Report of Inspector of Mines - Permitting

Mine Name/Number MYRA FALLS - HW 0800007 Visit Date 2018-06-26

General Observation: Kick off meeting at HW complex

Photo 6: Price 5 Portal pad.

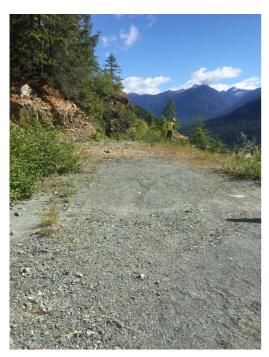
Ms. Pesonen indicated that any PAG waste rock identified in the Price 5 Portal pad would be prioritized for backfill in the underground during closure of the Price area (Photo 6).
